### **REMARKS**

This response is intended as a full and complete response to the final Office Action mailed February 24, 2005. In the Office Action, the Examiner notes that claims 1, 3-15, 17, 18, 20-35, 37-43, 45, 47-60, 62, 64-80, 82-98, 101-104, 107-116, 118 and 120-145 are pending of which claims 1, 3-15, 17, 18, 20-35, 37-40, 42-43, 45, 47-60, 62, 64-80, 82-98, 101-104, 107-113, 115-116, 118 and 120-145 are allowed and claims 41 and 114 are rejected. By this response, claims 41 and 114 are amended. The amendments to the claims are fully supported by the Specification as originally filed. For example, the amendments are supported at least by U.S. Patent No. 5,659,350, (which is incorporated by reference in the present Application and in U.S. Patent No. 5,990,927, of which the present Application is a divisional) at column 40, lines 13-33. Therefore the amendments to the claims add no new matter and the Examiner is respectfully requested to enter the amendments.

Fig. 12b

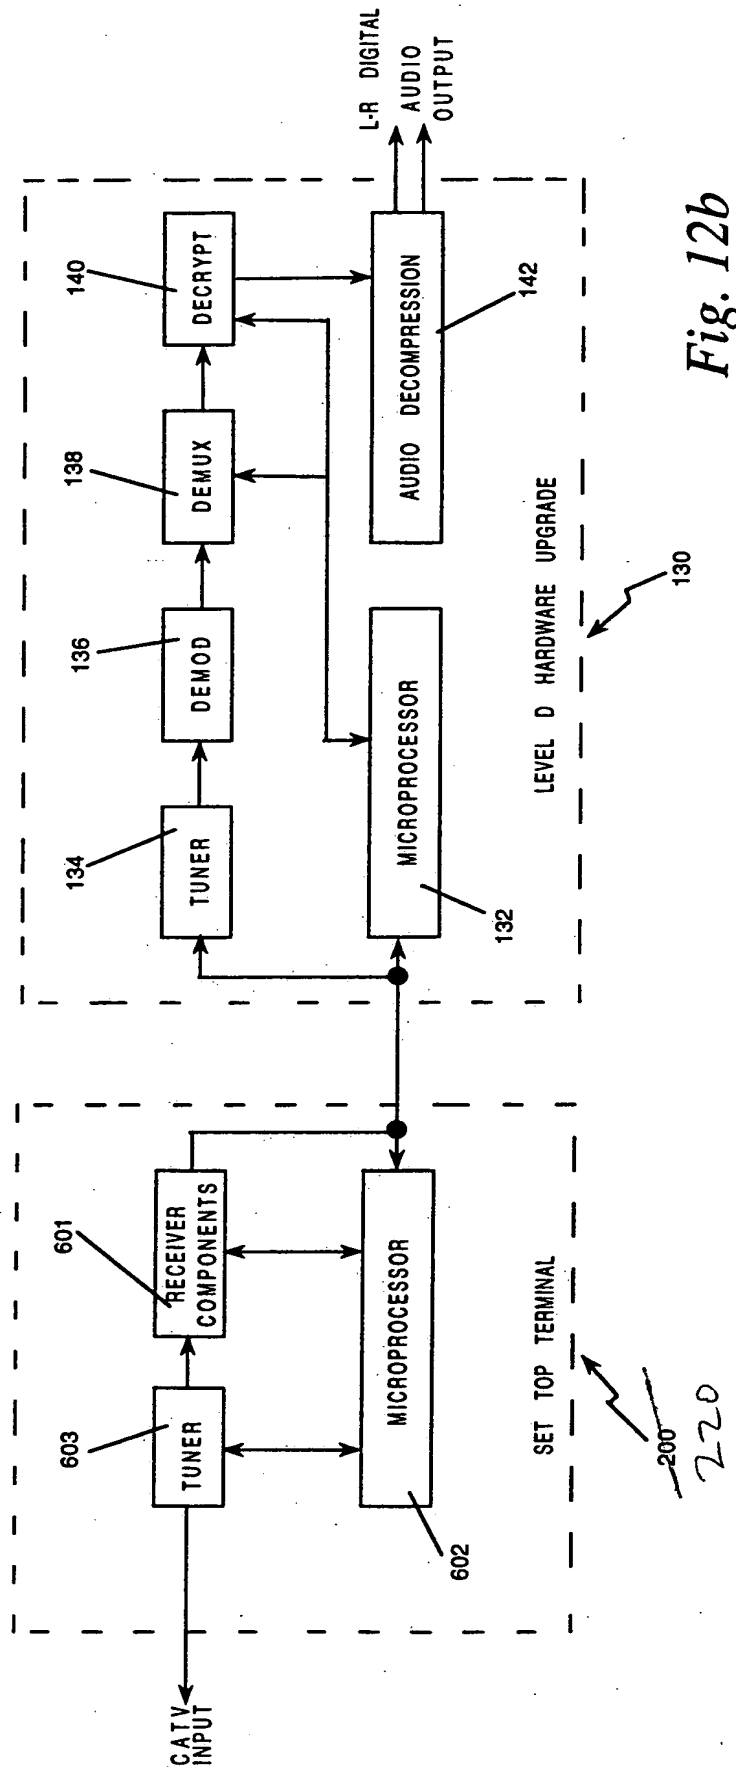
The Examiner has objected to the drawings for failing to comply with 37 C.F.R. §1.84(p)(4) because reference characters "200" and "220" have been used to designate a set top terminal (as shown in figures 12A and 12B). However, the Applicant hereby notes that the reason for this rejection has already been obviated by an amended drawing submitted on April 22, 1999. Nevertheless, a corrected replacement sheet of drawings in compliance with 37 C.F.R. 1.121(d) is hereby resubmitted. The replacement sheet presently submitted is identical in content to the replacement sheet submitted on April 22, 1999. The replacement sheet presently submitted, in comparison to the originally filed sheet of drawings, replaces the incorrect reference number "200" in Figure 12b with the correct reference number "220". Also presently enclosed is an annotated sheet of drawing showing the changes.
